Re: Paric Corporation Project No. 15051
15051-Webster University Interdisciplinary Science Building
CP-042 - RFI#162 Added Floor Box in Room 407

PROPOSED CHANGE ORDER

RFI 162 ADDED FLOOR BOX ROOM 407

203

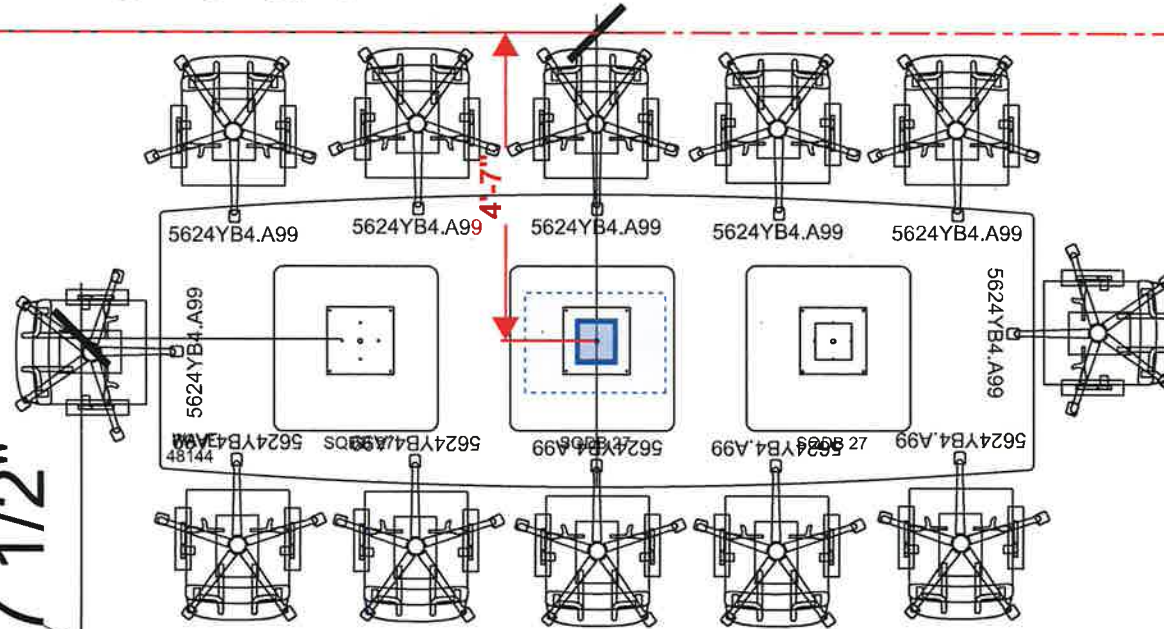
We need dimensions for the floor box in conference room 203. **SEE ATTACHED PLANS**

9'-6 3/4"

407

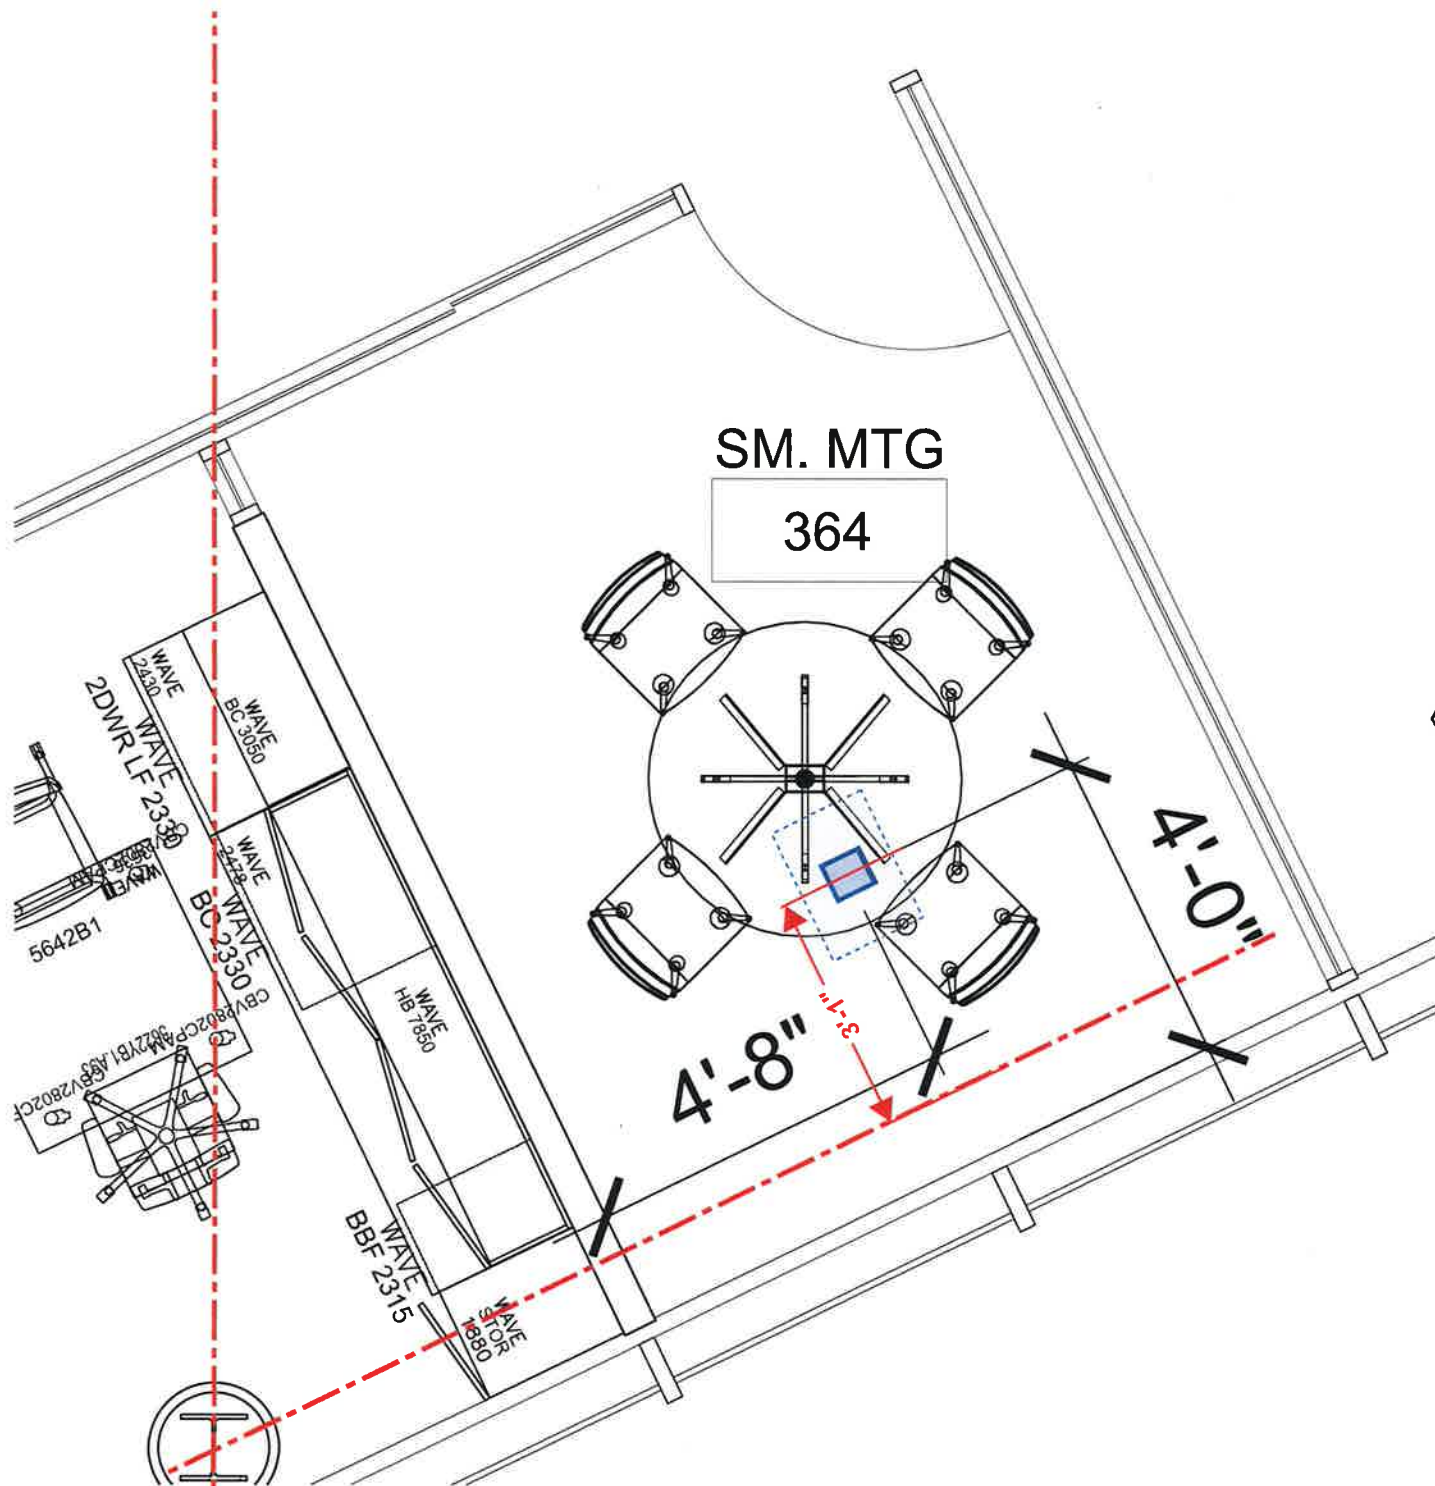
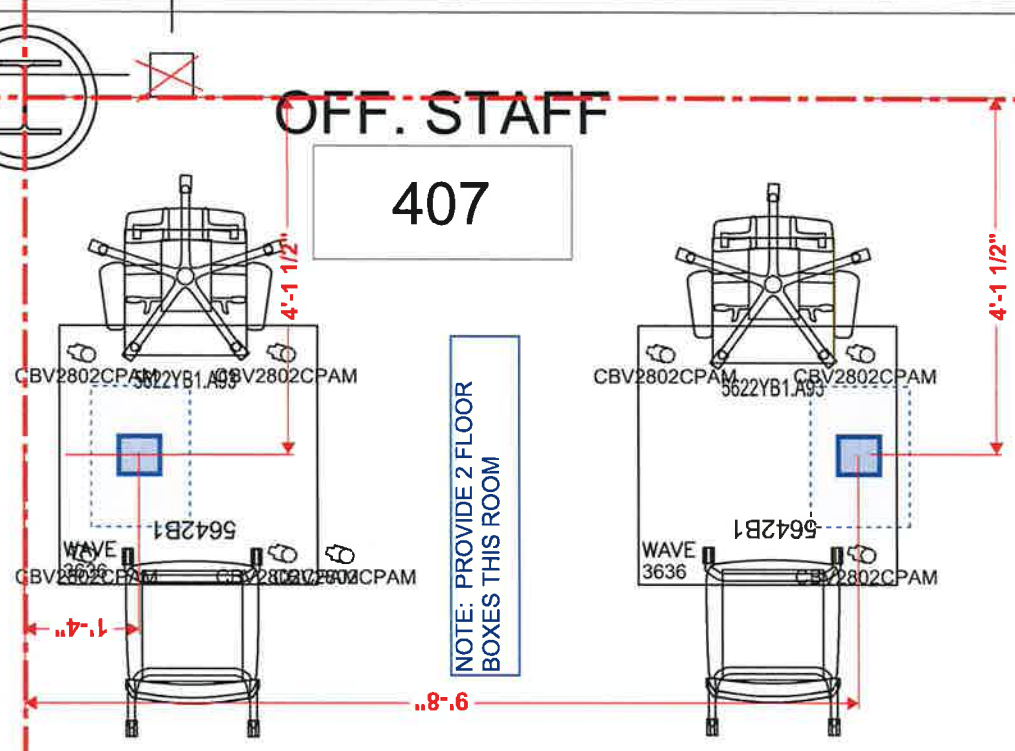
We need dimensions for the floor box in room 407. SEE ATTACHED PLANS

NOTE: PROVIDE 2 FLOOR
BOXES THIS ROOM

~~6'-6"~~

~~10'-5"~~
